Work Order ID 96691

Item Name: Crosstube Aft

DRAWING NO. D206-667-243	TITLE CROSSTUBE ASS'Y (206L HIGH AFT)	REV. C	DART AEROSPACE LTD ENGINEERING ORDER		D.E.O. NO. D206-667-243-C-1	SHEET NO. SHEET 1 OF 1	SCALE NTS
DRAWN <i>q</i>	CHECKED <i>ADS</i>	MFG. APPR. <i>RB</i>	APPROVED <i>MP</i>	DE APPR. <i>#</i>			
DATE 11.07.15	DATE 11.07.20	DATE 11.07.21	DATE 11/07/21	DATE 11.07.21

A	NEW ISSUE	CP	11.07.15
REV.	DESCRIPTION	BY	DATE
DESIGN	92	DART AEROSPACE LTD HAWKESBURY, ONTARIO, CANADA	
DRAWN	92		
CHECKED	ASS	DRAWING NO.	REV. A
MFG. APPR.	N/A	DSI 9565	SHEET 1 OF 1
APPROVED		TITLE	SCALE
DE APPR.		SUPPORT INSTALLATION CHANGE	NTS
DATE	11.07.15	COPYRIGHT © 2011 BY DART AEROSPACE LTD <small>THIS DOCUMENT IS PRIVATE AND CONFIDENTIAL AND IS SUPPLIED ON THE EXPRESS CONDITION THAT IT IS NOT TO BE USED FOR ANY PURPOSE OR COPIED OR COMMUNICATED TO ANY OTHER PERSON WITHOUT WRITTEN PERMISSION FROM DART AEROSPACE LTD.</small>

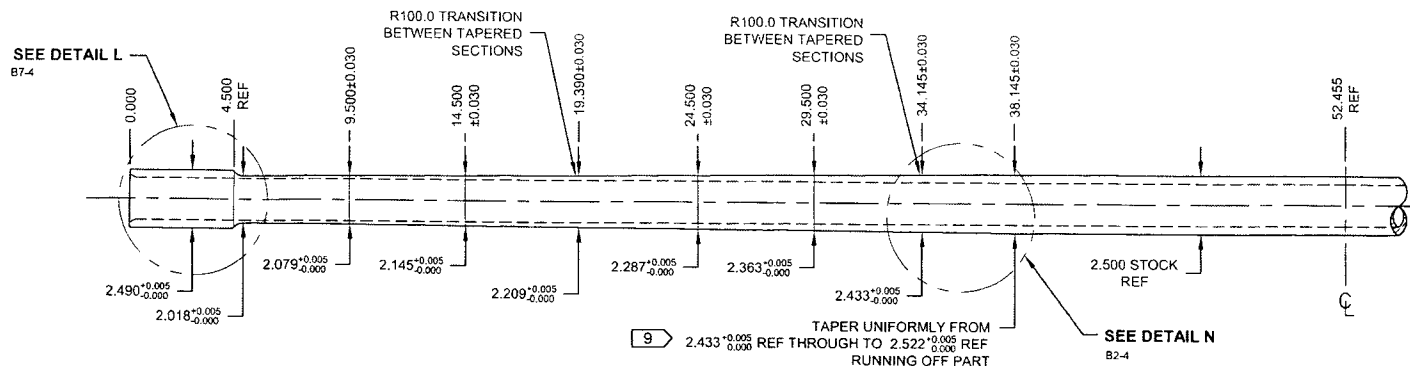
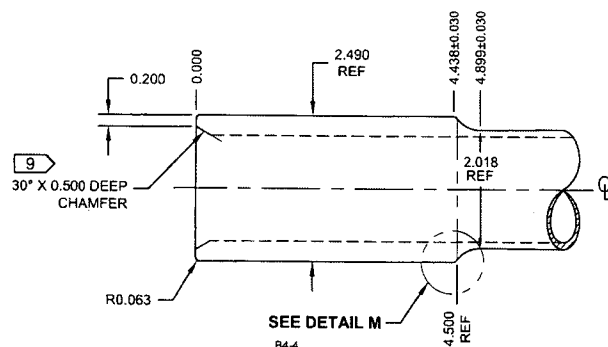
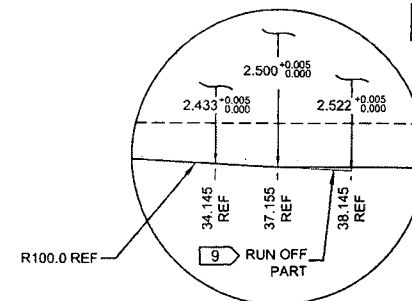
REPLACE MAGNOBOND WITH PROSEAL.

NOTE 12 & 15, SHEET 1 IS AMENDED AS FOLLOWS:

12) TO INSTALL D2892-1 SUPPORT: ABRAD MATING SURFACE OF SUPPORT AND CROSSTUBE WITH 180-GRIT SANDPAPER AND REMOVE RESIDUE WITH MEK (OR EQUIVALENT). APPLY A 0.04" TO 0.07" THICK LAYER OF PROSEAL 890 CLASS B-2 (OR AMS-S-8802 CLASS B-2) SEALANT TO MATING SURFACE OF SUPPORT.
